**REVIEW OF THE DRAFT SUPPLEMENT TO THE WIPP
ENVIRONMENTAL IMPACT STATEMENT DOE/EIS-0026-S-2**

Environmental Evaluation Group
New Mexico

April 1997

Figure 1. Proven and Probable Hydrocarbon Reserves for Brushy Canyon (after Broadhead et al, 1995, as published in EEG-62).

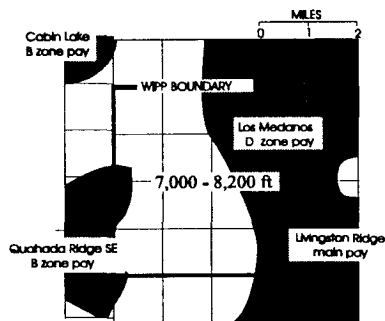
Hydrocarbon resource is a very important issue and merits much more than a cursory overview by three short paragraphs.

The SEIS should have at least a series of maps showing proven and probable reserves at the various reservoir depths (eg. Figure 1), an illustration of the geologic cross section of the area resources and current production (eg. Figure 2), and a current map indicating drilling interest in the area and the extent of drilling delayed due to the presence of potash (eg. Figure 3). See EEG-62 (Silva, 1996) for a discussion of these figures.

Figure 4. Estimated areal extent of potash reserves.

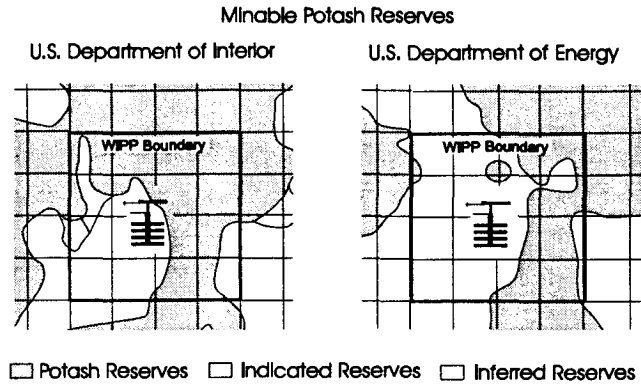
This section should have maps showing the extent of lease grade potash reserves including the extent of potash reserves under the WIPP Site. Further, the SEIS should rely on the official position of the Department of Interior. The text should then discuss the maps and the impact of WIPP on the potash industry and the potential impact of potash mining on the WIPP based on potash reserve estimates by the Department of Interior.

Figure 6. Solution mining of the Salado Formation.

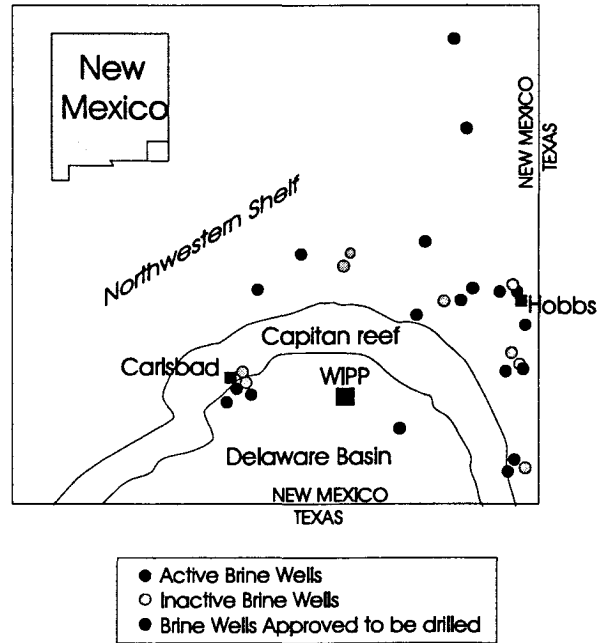
There needs to be a section discussing the decades long activity of solution mining of halite, shown in Figure 6, from the Salado Formation to produce brine for drilling oil and gas wells throughout southeast New Mexico.

Figure 7. Postulated correlation between oilfield salt water injection and water level rises.

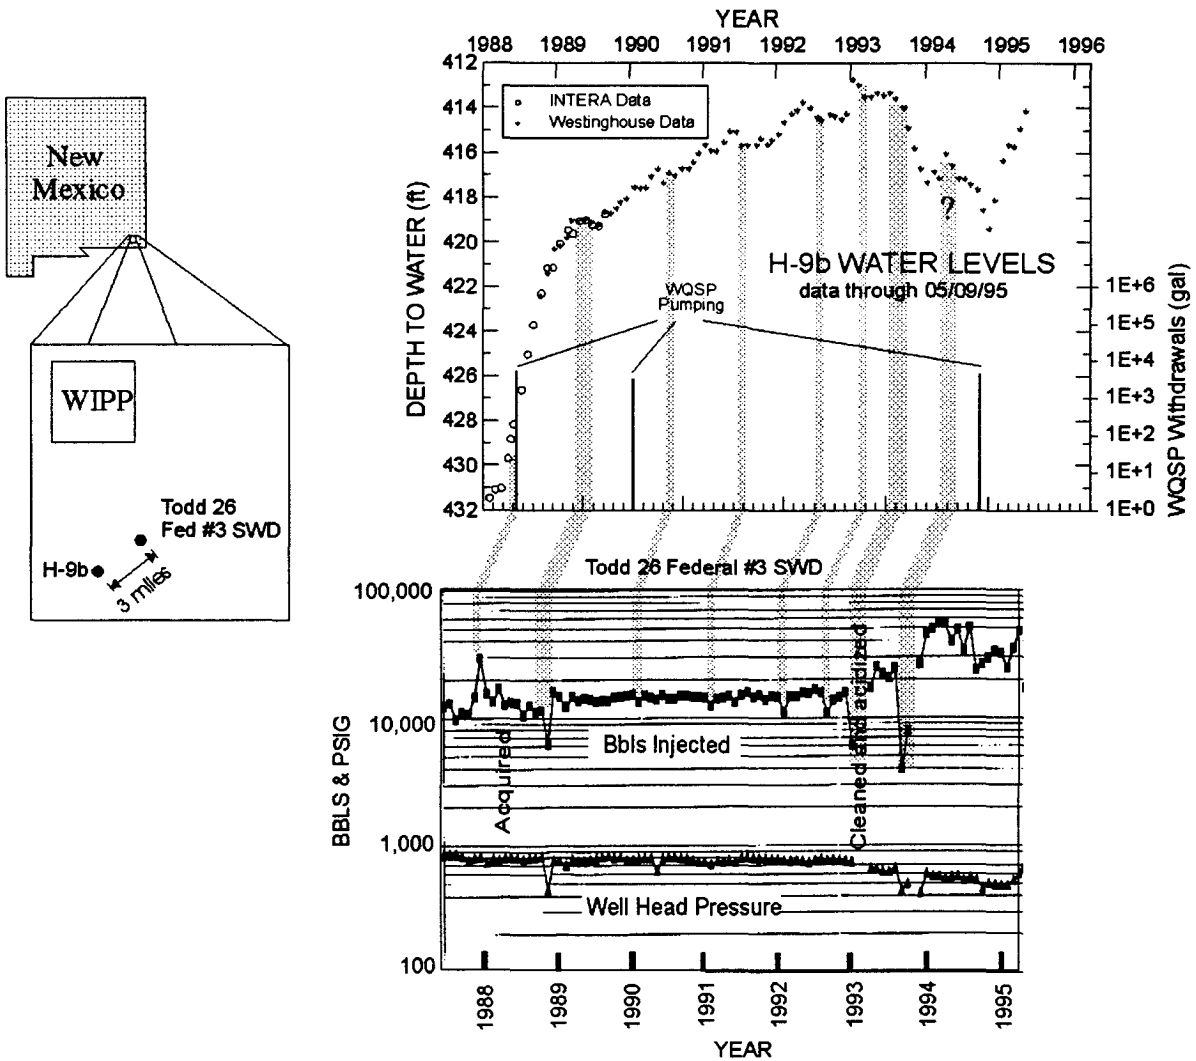
The discussion of the water level rises in the Culebra Aquifer and the potential impact of salt water disposal wells would be clearer by preparing and presenting a figure such as the one shown here and published in EEG-62.
